Customer No.: 31561
Application No.: 10/711,540
Docket No.: 13365-US-PA

AMENDMENT

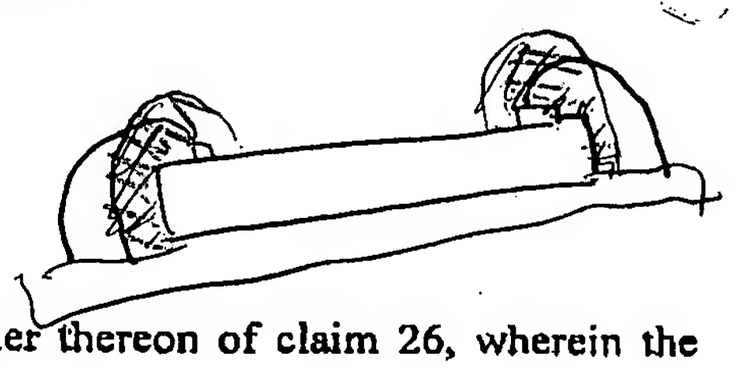
112, 1st paragraph

103

obvious to modify the polymer covering @ 4 corners of the
